TAX ID #03-342344
ON-SITE SEWAGE DISPOSAL SYSTEM
HOWARD COUNTY HEALTH DEPARTMENT
BUREAU OF ENVIRONMENTAL HEALTH

Rylea Homes, Inc IS PERMITTED TO INSTALL ALTER
ADDRESS: PO Box 68, Glenwood MD 21738 PHONE NUMBER: 410-489-6030
SUBDIVISION: FOXTAIL RUN LOT NUMBER: 3
ADDRESS: 13702 GREYFOX RUN PROPERTY OWNER: RIVER HOMES & INC.
SEPTIC TANK CAPACITY (GALLONS): 1250 OUTLET BAFFLE FILTER REQUIRED
PUMP CHAMBER CAPACITY (GALLONS): _____ COMPARTMENTED TANK REQUIRED
NUMBER OF BEDROOMS: 4
SQUARE FEET PER BEDROOM: 180
LINEAR FEET OF TRENCH REQUIRED: 137 HOUSE SERVED BY PUBLIC WATER

FOUNDATION CERTIFICATION
LOT 3
GREYFOX RUN
FOXTAIL RUN

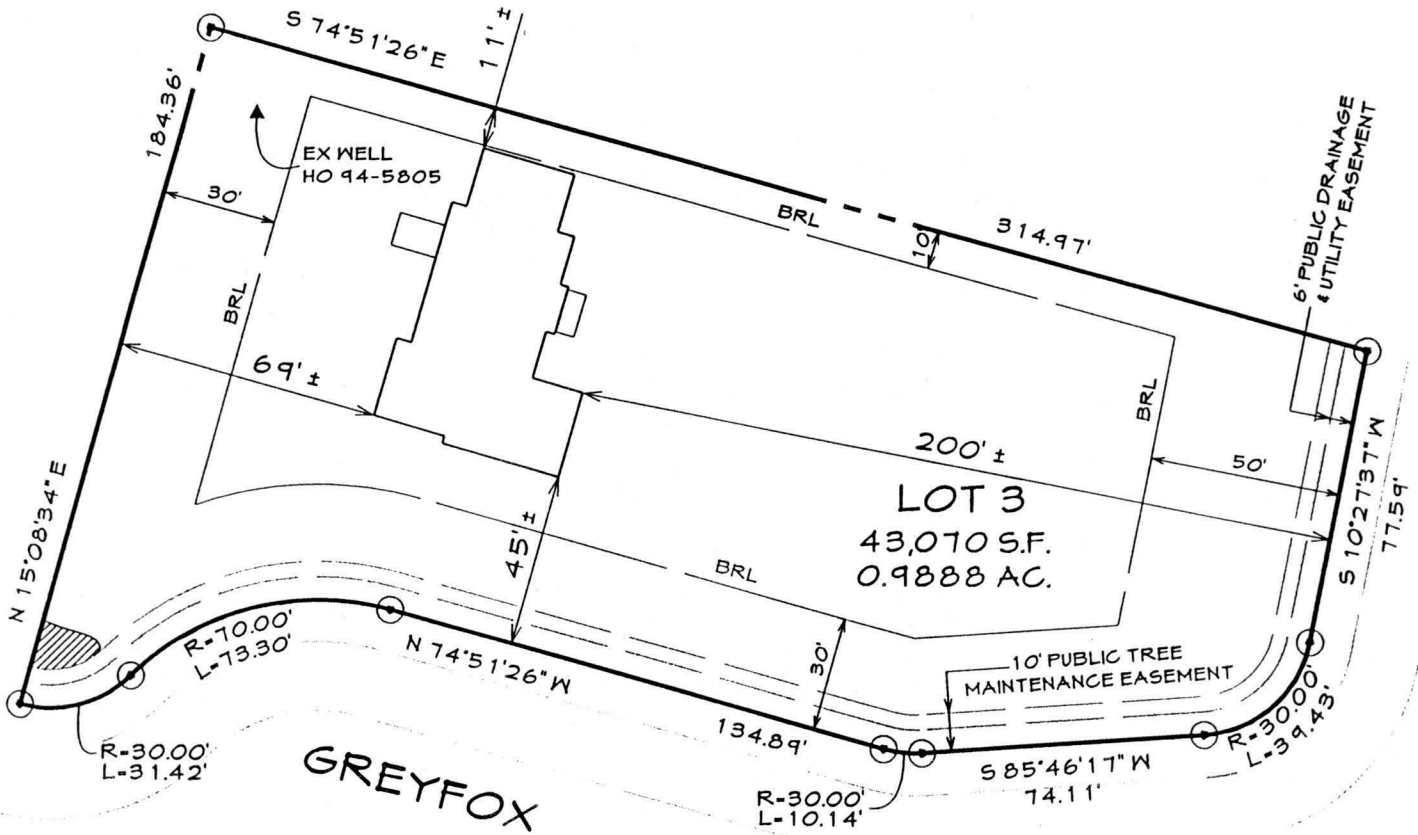
PRE-CONSTRUCTION 11/8/05 To install 2 trenches on contour across the top of the septic easement. Make trenches as long as possible. Place the distribution box near the upper right corner. Wrong septic tank installed - single compartment. Put a 500 gallon tank after the 1250. (BB) 11/9/05 500 gallon tank installed. Top trench done. (BB) 11/10/05 Bottom trench done. Need baffles and manhole cleanout on 500 gallon tank. (BB) 11/16/05 Baffles and cleanout installed on 500 gallon tank. (BB)
